# Product Change Notification

### **Bourns® Model SM-LP-5001 and SM-LP-5002 Series Surface Mount Line Matching Transformers *Change to Carrier Tape Specifications***

### Existing Tape Carrier Dimensions

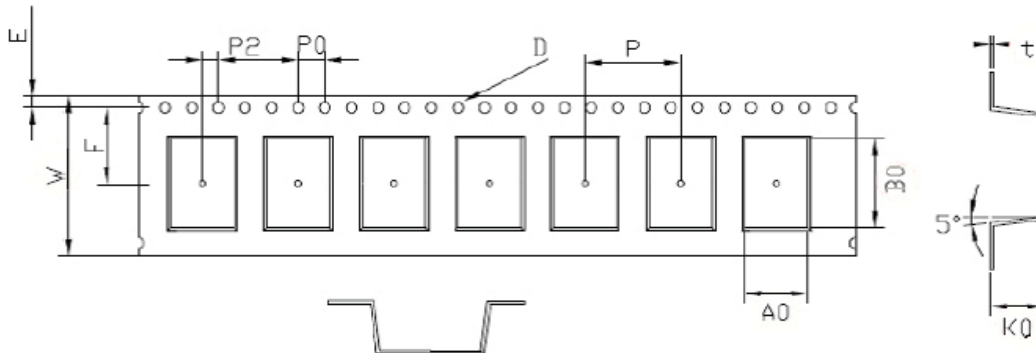
ITEM	W	A0	B0	K0	P	F	E	D	D1	P0	P2	T
DIM	24.00 <sup>+0.30</sup> / <sub>-0.30</sub>	10.50 <sup>+0.10</sup> / <sub>-0.10</sub>	14.30 <sup>+0.10</sup> / <sub>-0.10</sub>	7.70 <sup>+0.10</sup> / <sub>-0.10</sub>	16.00 <sup>+0.10</sup> / <sub>-0.10</sub>	11.50 <sup>+0.10</sup> / <sub>-0.10</sub>	1.75 <sup>+0.10</sup> / <sub>-0.10</sub>	1.50 <sup>+0.10</sup> / <sub>-0.00</sub>	1.50 <sup>+0.10</sup> / <sub>-0.00</sub>	4.00 <sup>+0.10</sup> / <sub>-0.10</sub>	2.00 <sup>+0.10</sup> / <sub>-0.10</sub>	0.40 <sup>+0.05</sup> / <sub>-0.05</sub>

### Modified Tape Carrier Dimensions

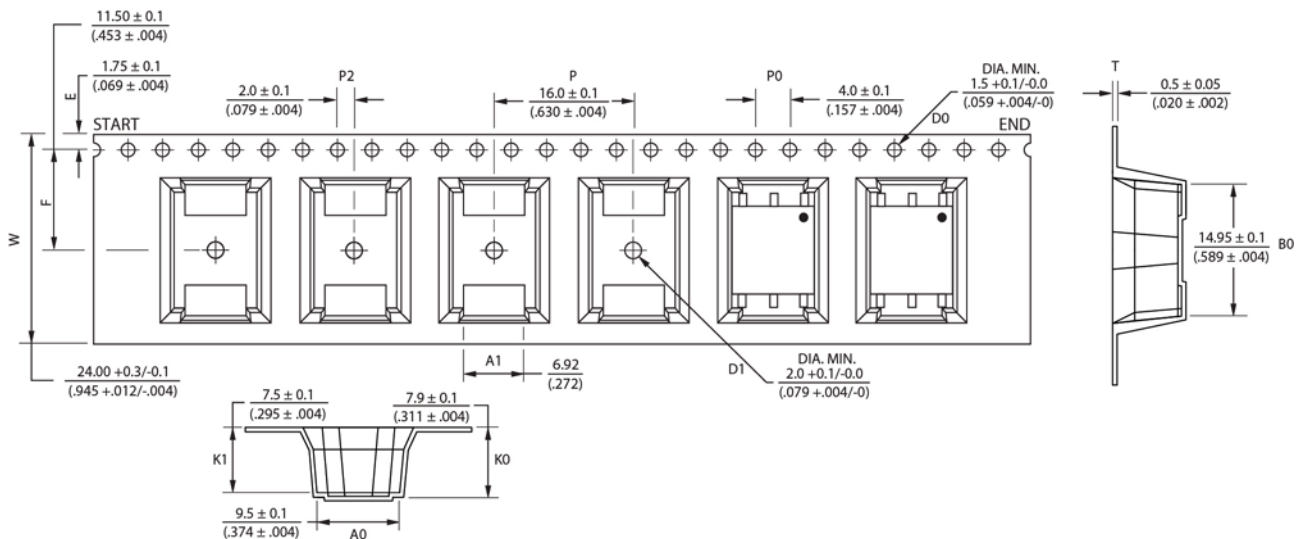
Bourns has decided to change the carrier tape specifications for the Model [SM-LP-5001](#) and [SM-LP-5002](#) Series Surface Mount Line Matching Transformers. The carrier tape has been redesigned to help limit lateral movement of the component to within 1 mm in compliance with the EIA-481-D Standard. The form, fit and function of the transformer will remain the same. Specifications of the carrier tape are provided on the following page.

ITEM	W	A0	B0	K0	P	F	E	D0	D1	P0	P2	T	A1	K1
DIM	24.00 <sup>+0.30</sup> / <sub>-0.10</sub>	9.50 <sup>+0.10</sup> / <sub>-0.10</sub>	14.95 <sup>+0.10</sup> / <sub>-0.10</sub>	7.90 <sup>+0.10</sup> / <sub>-0.10</sub>	16.00 <sup>+0.10</sup> / <sub>-0.10</sub>	11.50 <sup>+0.10</sup> / <sub>-0.10</sub>	1.75 <sup>+0.10</sup> / <sub>-0.10</sub>	1.50 <sup>+0.10</sup> / <sub>-0.00</sub>	2.00 <sup>+0.10</sup> / <sub>-0.00</sub>	4.00 <sup>+0.10</sup> / <sub>-0.10</sub>	2.00 <sup>+0.10</sup> / <sub>-0.10</sub>	0.50 <sup>+0.05</sup> / <sub>-0.05</sub>	6.92 <sup>+0.10</sup> / <sub>-0.10</sub>	7.50 <sup>+0.10</sup> / <sub>-0.10</sub>
